# SUNSET VILLAGE FILING NO. 4

## CONSTRUCTION PLANS

EPC STORMWATER REVIEW COMMENTS  
IN ORANGE BOXES WITH BLACK TEXT

MODIFIED FOR S.I.A. CD SET  
RICHARD D. LYON, PE  
ATWELL, LLC.  
DECEMBER, 2021  
EPC PROJ.: CDR-21-008

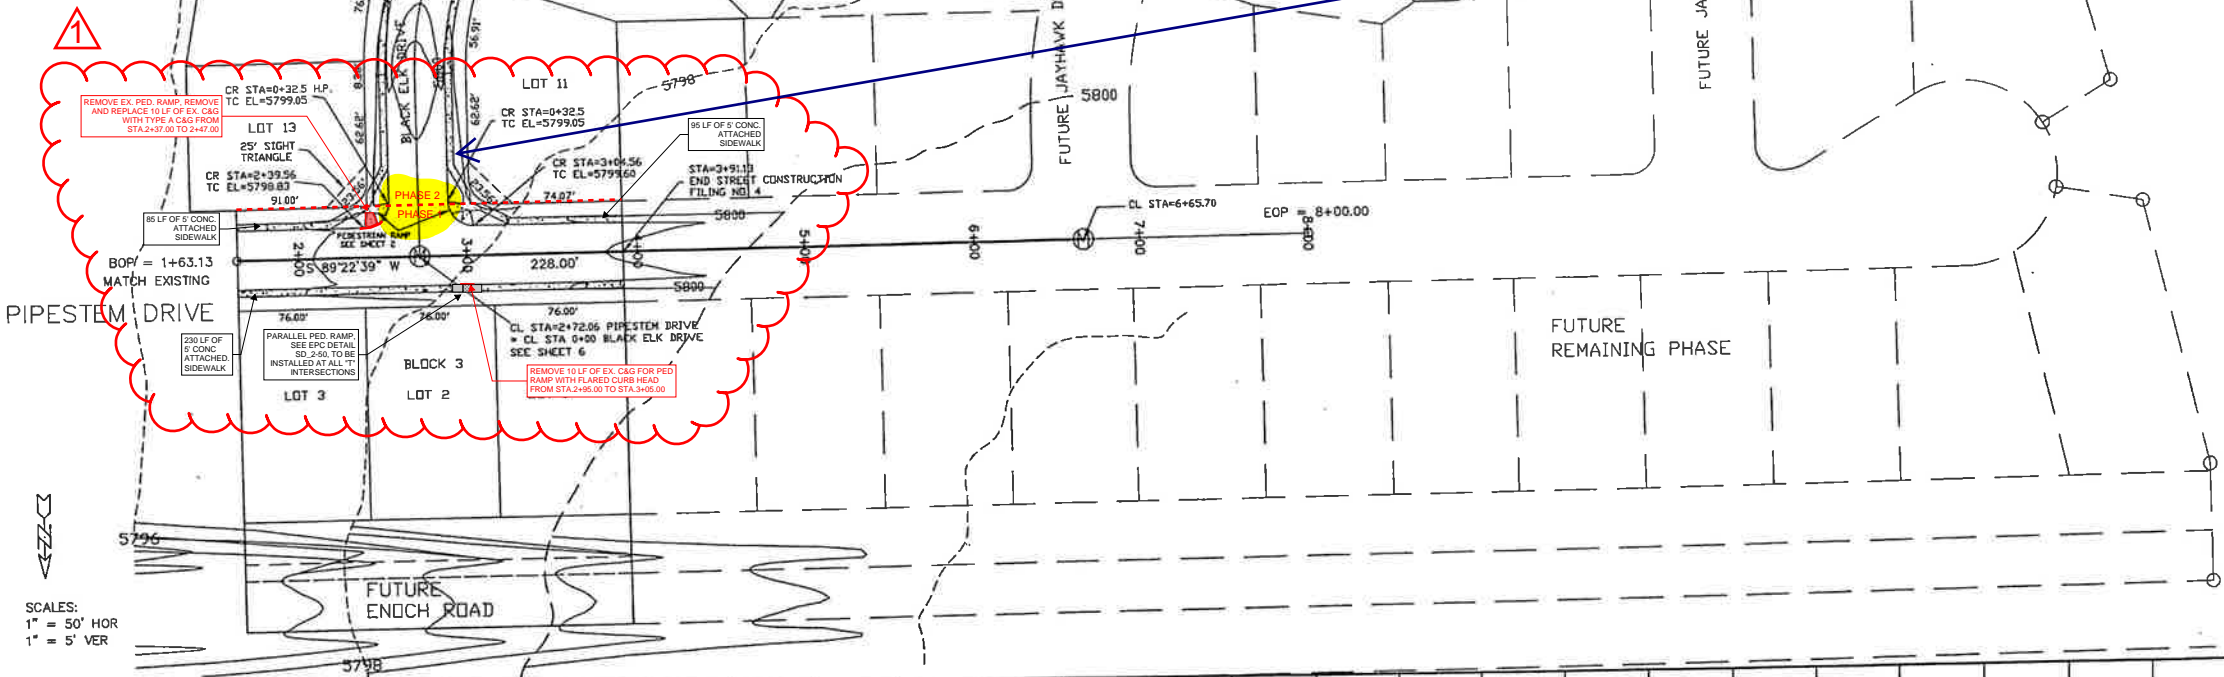
Sheet 3 notes  
Pipestem as part of  
Phase I. Update  
either the phase  
boundary or sheet 3  
for consistency.  
Update the FAE  
accordingly.

Correct, updated on sheet 3 per  
Phasing plan.

PROJECT: PIPESTEM DRIVE STREET & SANITARY SEWER  
FROM: 1+63.13 TO: 6+65.70  
SUBDIVISION: SUNSET VILLAGE FILING NO. 4  
DRAINAGE BASIN: TELEPHONE EXCHANGE  
JOB NO. D:\PROJ\X00-0908\RCP01001.DWG SHEET 3 OF 22

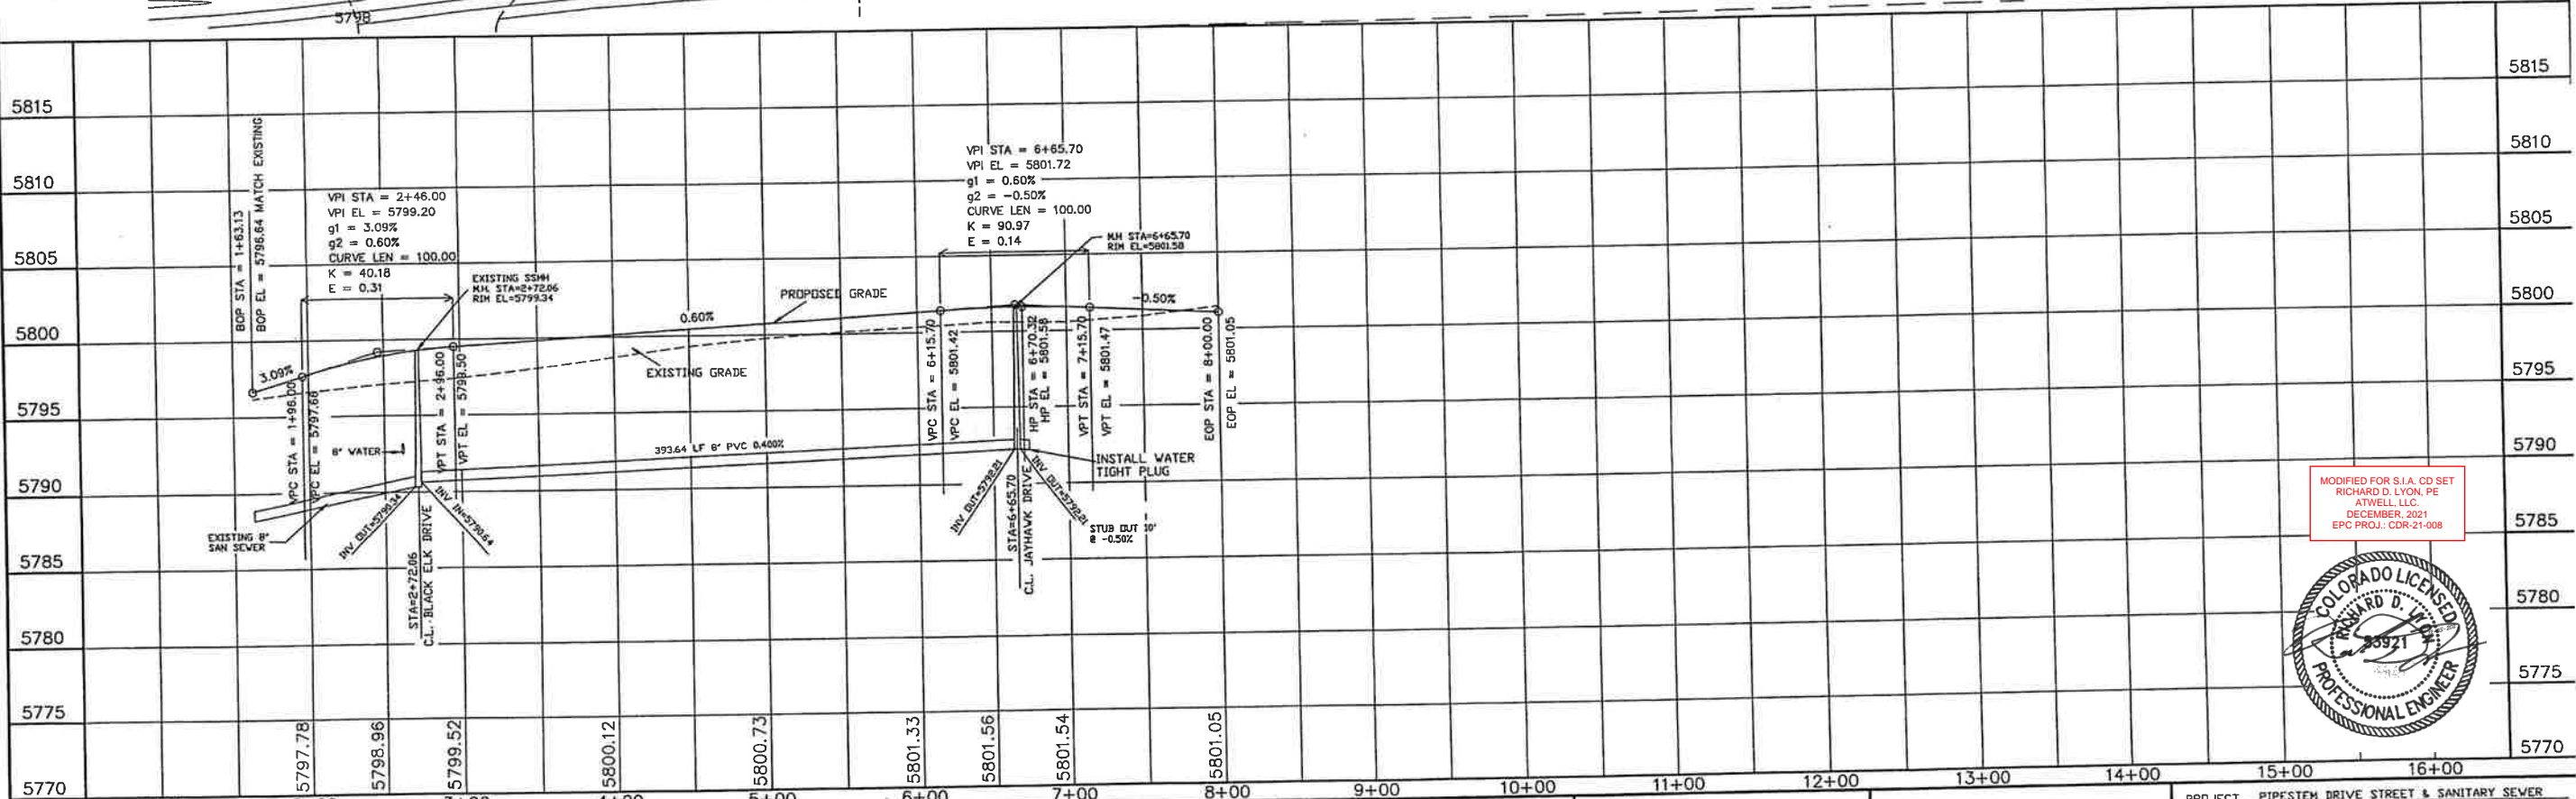
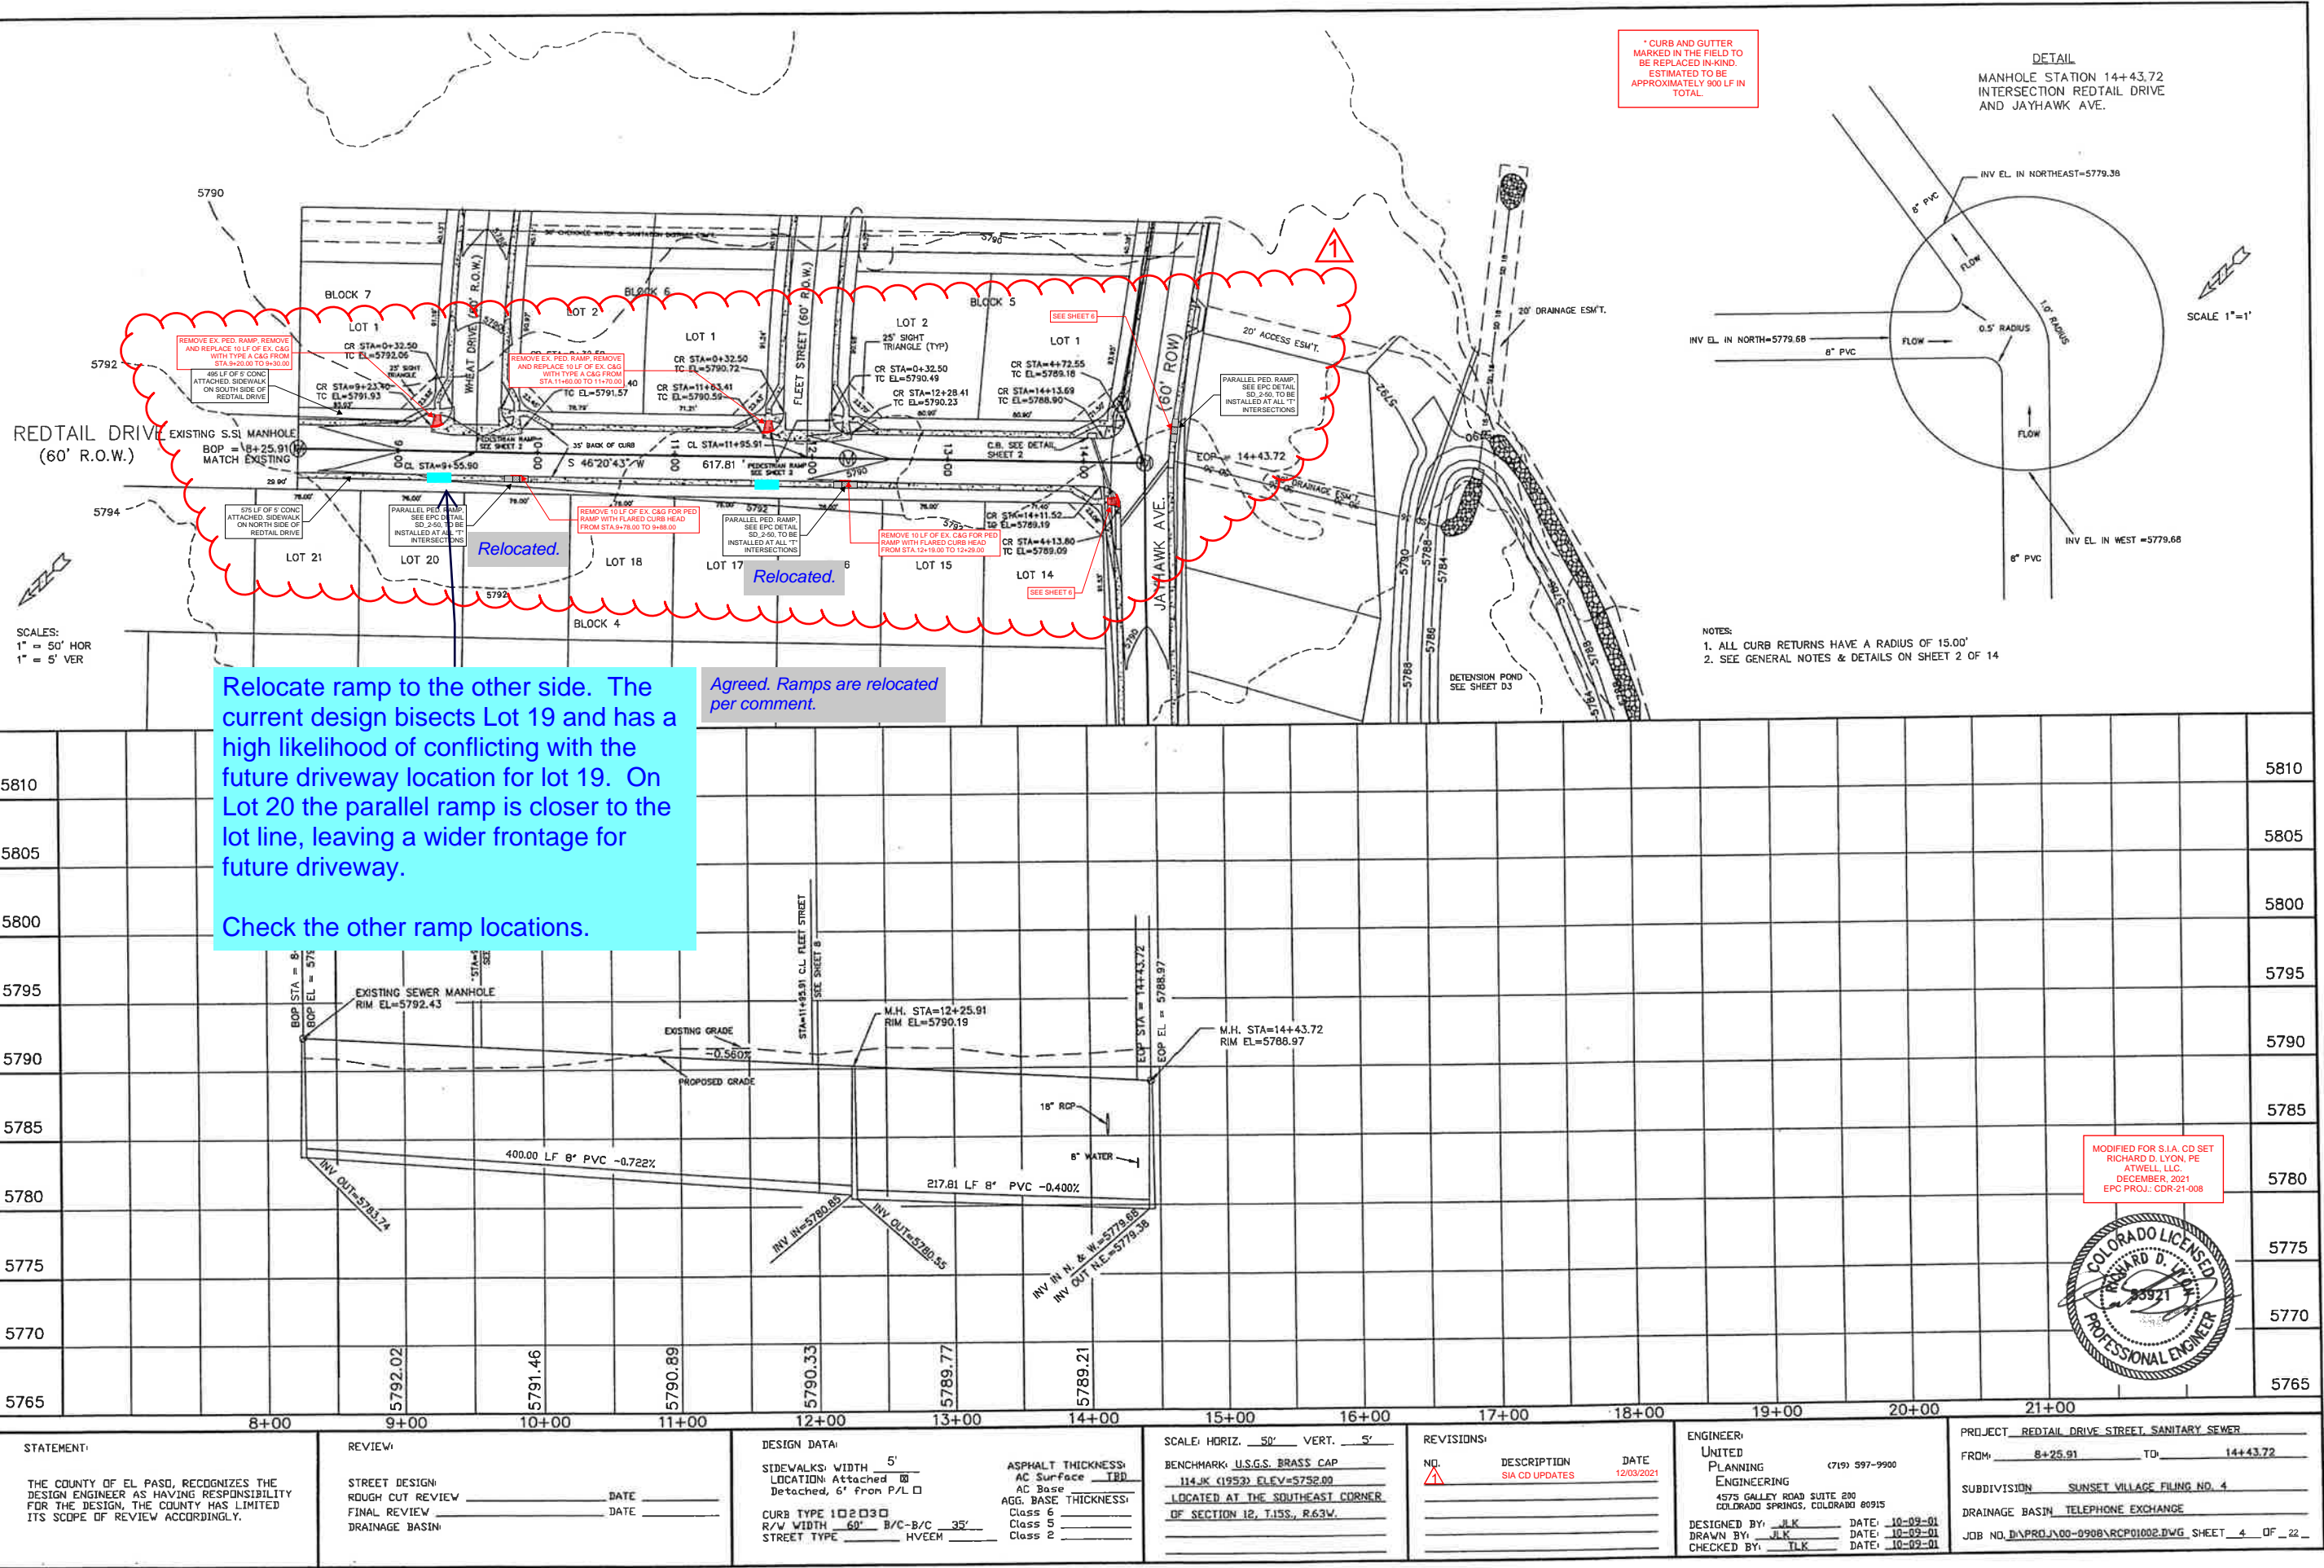
Phase I or 2? see  
comment on sheet 1

Correct, these were backward.  
Revised. Phase indicators  
now added in corners of plan  
sheets.

Phase indicators added.

DETAIL  
MANHOLE STATION 14+45.26  
INTERSECTION JAYHAWK AVE.  
AND RED TAIL DRIVE

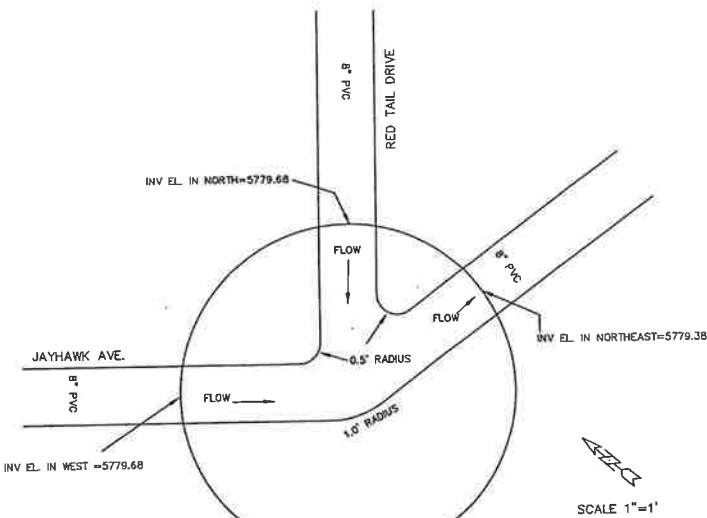
Relocate ramp to the other side.

Agreed. Ramps are relocated per comment.

Relocated.

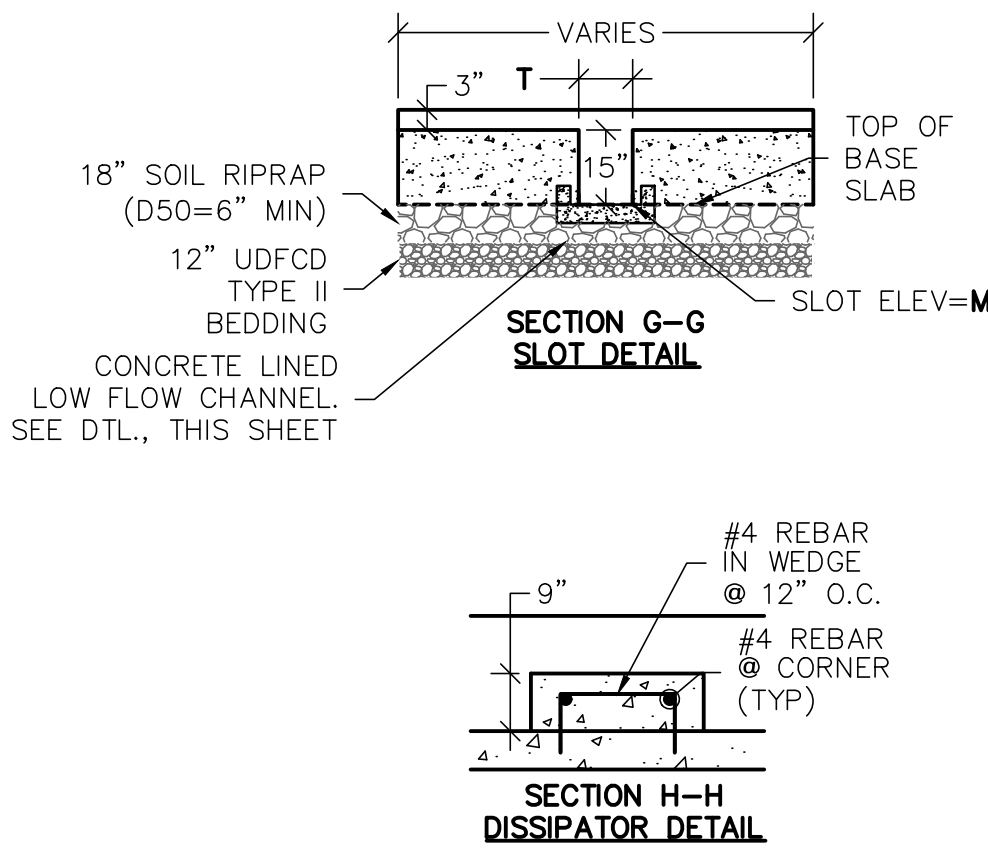
Replace D with the actual dimension. Typical for all dimension labels on this detail.

Provide Forebay sizing calcs in FDR. To do so, you could use EDB tab of the UD-BMP spreadsheet  
Now included in FDR.

Provide section E-E detail  
Now provided as section H-H.

Addressed.

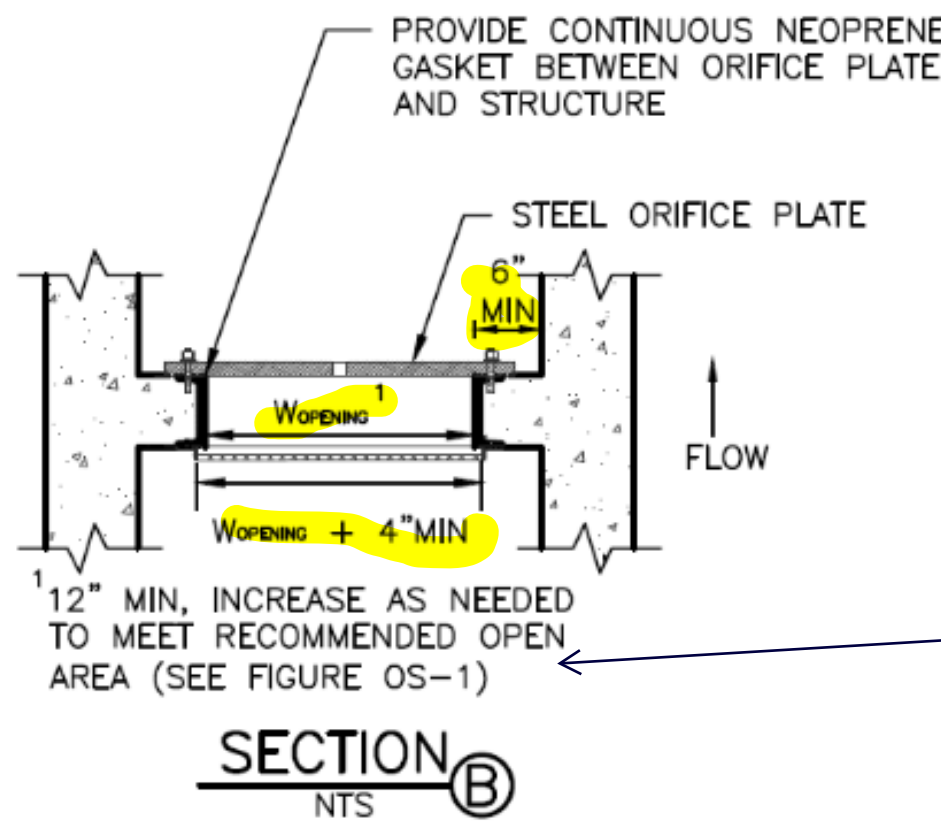
Trash rack to be Amico Klemp KRP Series aluminum bar grate (Figure 6-b), US Filter or Johnson stainless steel well screen with #93 VEE wire (Figure 6-a), or equivalent (per EPC DCMv2, Chap 4.3 and MHFD Detail T-12). Refer to Step #9 on the EDB tab of the UD-BMP spreadsheet for when to use well screens vs bar grates.

Callout the trash screen product to be installed.

Add this detail or update the existing details to include the following information:  
1. Identify the width of the opening  
2. Width of the trash screen  
3. Width of orifice plate.

Information now provided.

Now added.
